# TECHNICAL BULLETIN

## ALL MODELS TRUCK AIR SUSPENSION TORQUE ROD UPDATE ULTRA ROD

**No:** TRUCK AUS-013  
**Subject:** *Product Update*  
**Date:** December 2000 **Revision:** A

Figure 1

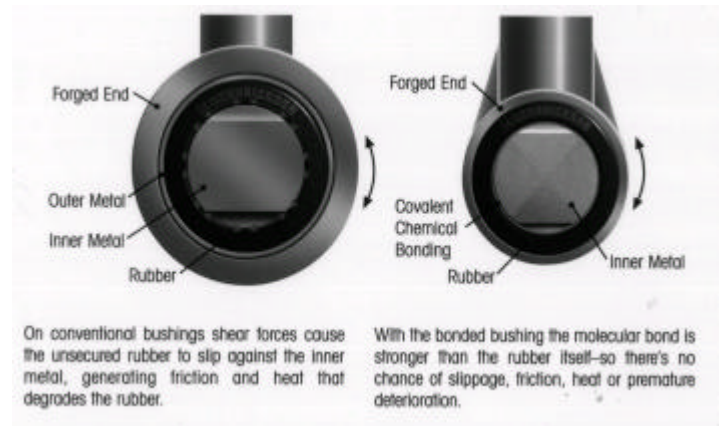
The Ultra Rod end is also smaller (2.5”Dia) than former Hendrickson torque rods (3.5”Dia). Refer Figure 1.

Figure 2

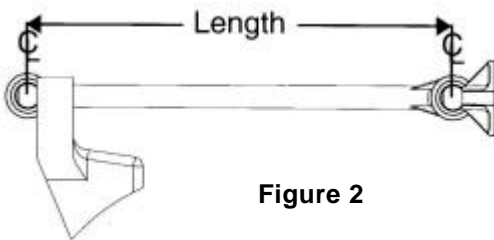
### Outside Mount

Measure centre to centre of old torque rod. Make the new torque rod the same length.

Figure 3

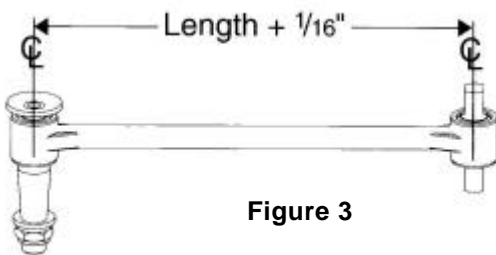
### Taper Pin to Straddle Pin Mount

Measure centre to centre of old torque rod and add 1/16" to make new torque rod.

Figure 4

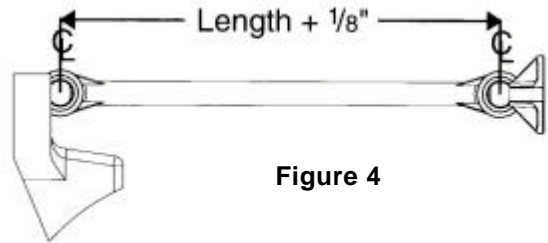
### Inside to Inside Mount

Measure from the centre of the old torque rod and add 1/8" to make new torque rod.
